Instrument Cluster Reprogramming (MID
140)
GU

FSB 381-020, Instrument Cluster, Reprogramming (MID 140)

(October 2017)

W7086748

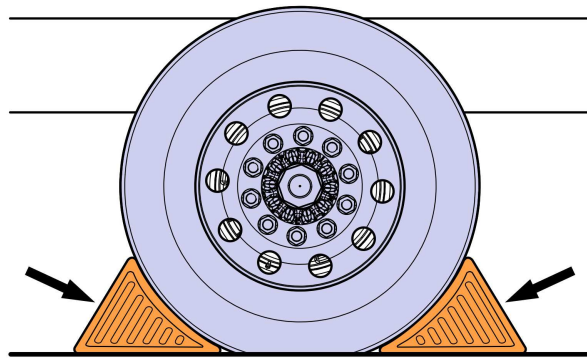
On certain Mack models built between August 17, 2015 and August 18, 2017, with a Cummins™¹ engine, it may not be possible to request a regen using the cluster stalk switches. This is due to the way the trucks were ordered, automatic regen only and the removal of the "DPF Smart Switch". For most trucks auto regen will be sufficient but for trucks that do short hauls and multiple stops and goes throughout the day the auto only regen may not allow enough aftertreatment cleaning. In order to fix this issue you can change the setup to allow regen requests from the cluster stalk switches by following the procedure below:

- 5 Connect the vehicle to Premium Tech Tool.
- 6 Run Accessory Kit 85152252
- 7 Reprogram the Instrument Cluster (MID140).
- 8 Using Premium Tech Tool, under Parameter Programming, change parameter **IBQ** to "**1**" or "**On.**"
- 9 Disconnect the vehicle from Premium Tech Tool.
- 10 Connect the vehicle to Cummins Insite™² diagnostic software tool.
- 11 Under "**Features and Parameters**" expand the "**Aftertreatment**" list.
- 12 Then expand the "**Diesel Particulate Filter**" list.
- 13 Then expand the "**Automotive Mobile Regeneration**" list.
